Our ref: 100148-PEF-ZZ-XX-RP-YE-000400
Planning Ref: BN/11/22/OUT
EA Ref: HA/2022/123981/01-L01

05th October 2022

BARNHAM EASTERGATE WESTERGATE – RESPONSE TO ENVIRONMENT AGENCY’S HOLDING OBJECTION IN RELATION TO FLOOD RISK ISSUES

Drawing Title:
WATER DEPTH BASELINE
1% AEP + 35% CLIMATE
CHANGE

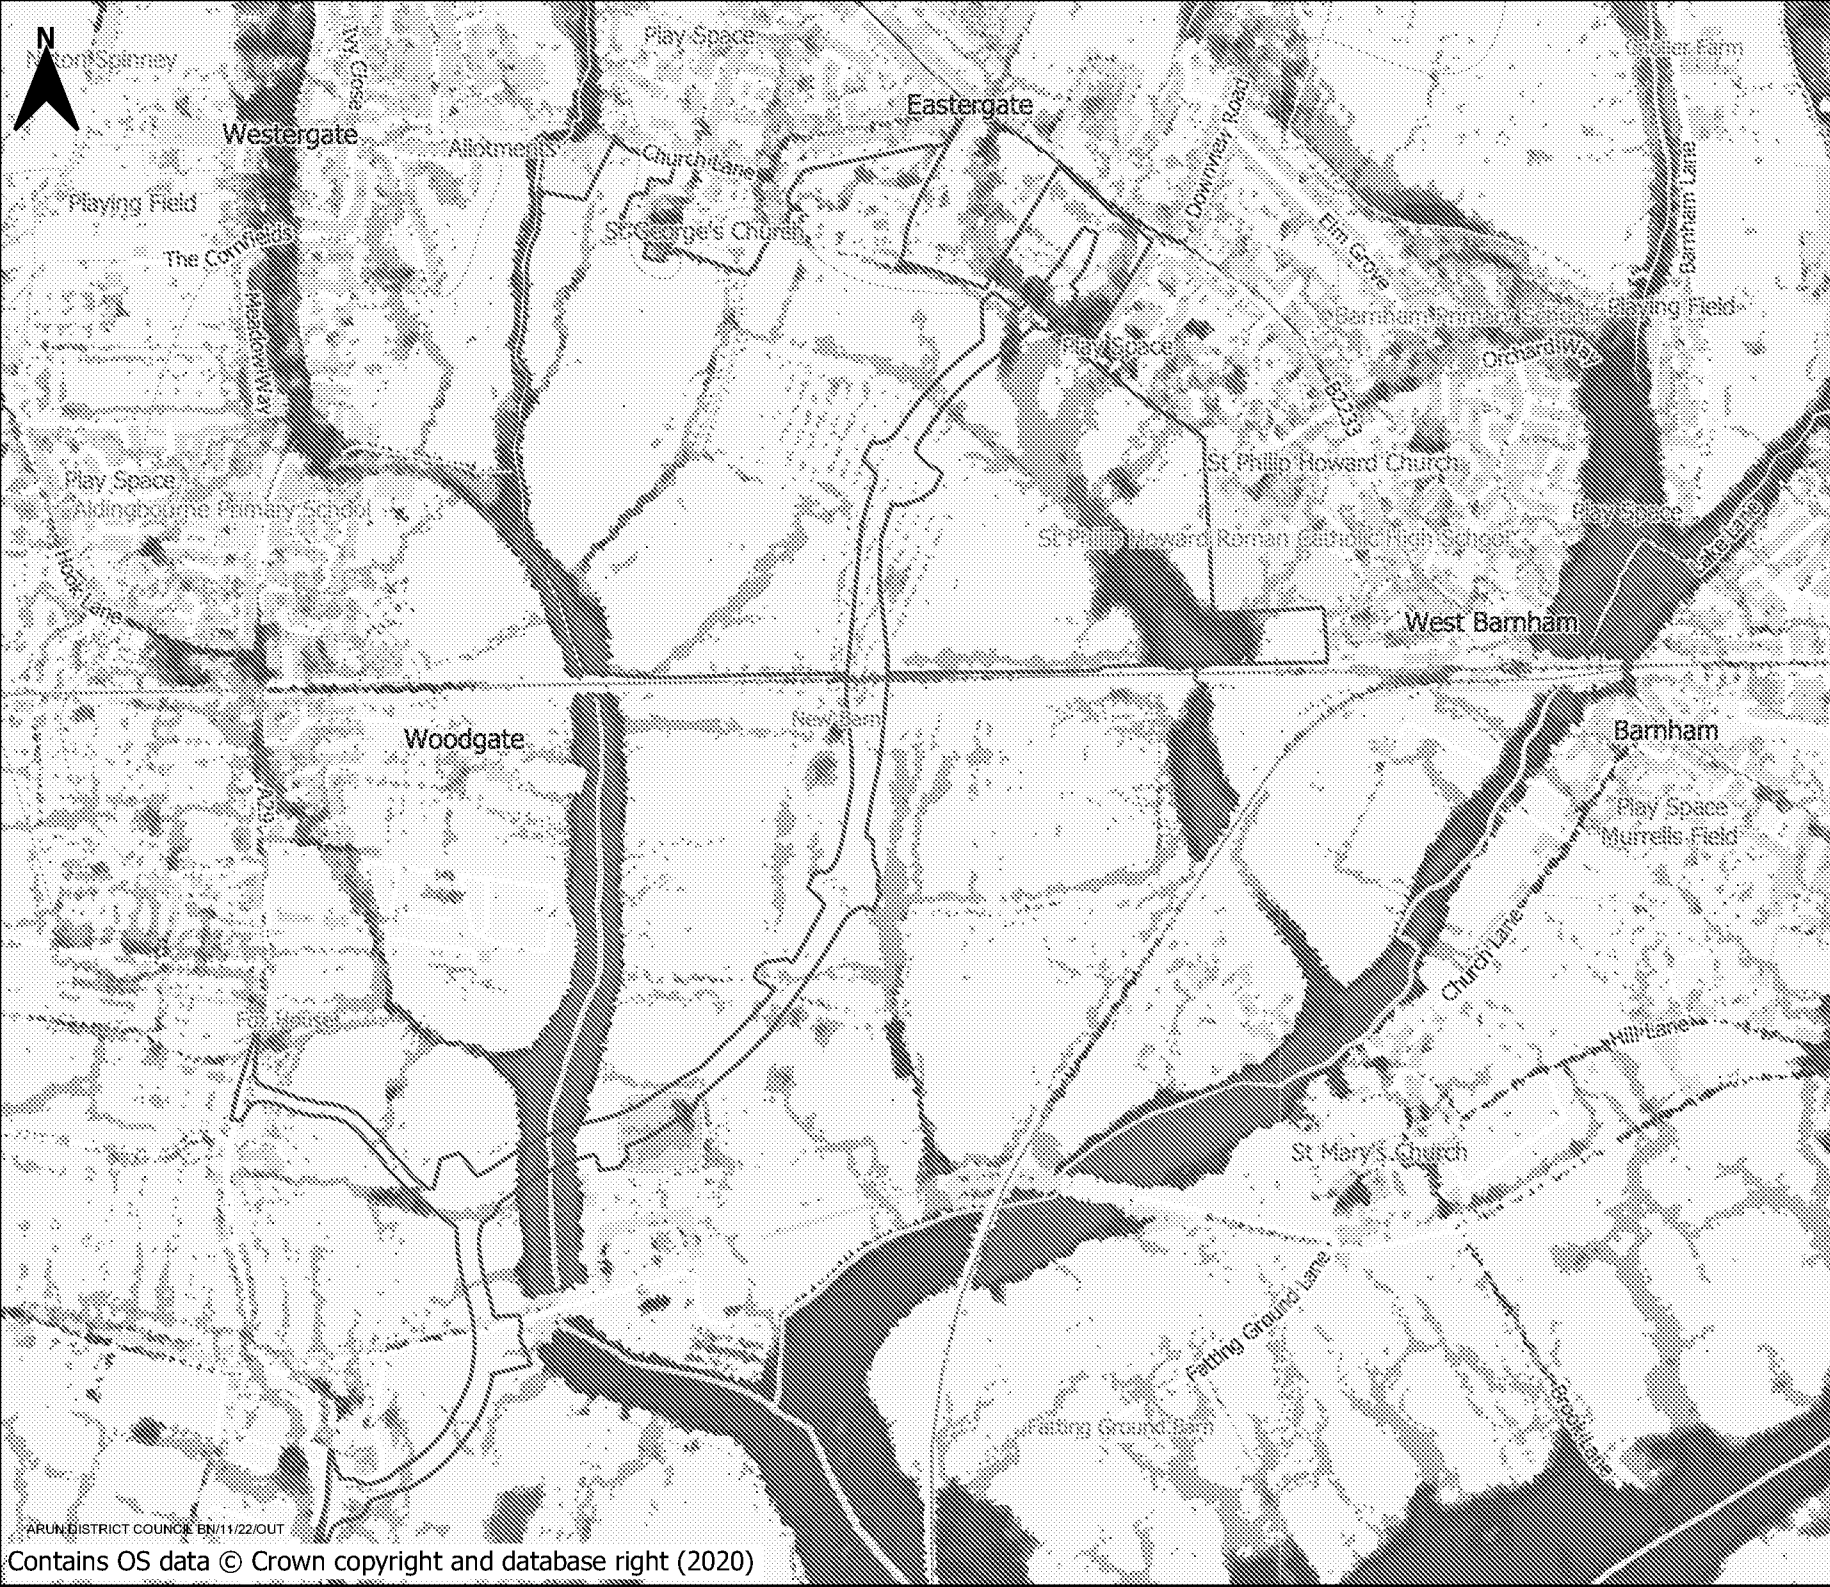
The EA’s response states that “...we would need to see reference to the latest Climate Change allowances...and their potential impact on the 200m multi-span Lidsey Rife Bridge option at multiple points.”

In response to the Environment Agency's comment, the analysis has been revised to take into account the latest climate change allowances, which suggests for such schemes the higher central allowance should be used. For the Arun and Western Streams management catchment this equates to a 36% increase in peak river flows to the 1% annual probability design event. The Environment Agency model included hydrology for the 35% increase event, which has been used to assess the proposals in line with these updated allowances. Results are appended to this letter for reference.

This demonstrates that with the bridge embankments in place, there is a minor increase in peak flood depth within the corresponding flood cell, which extends from the railway to the north to the canal towpath to the south (see drawing A11394-PEF-ZZ-XX-SK-YE-0804). These increases are in the order of 0.03m (30mm) within an area flooding to an average depth of 1.0-1.5m (see drawing A13394-PEF-ZZ-XX-SK-YE-0802), which in the context of the proposals is not considered a significant change to the floodplain.
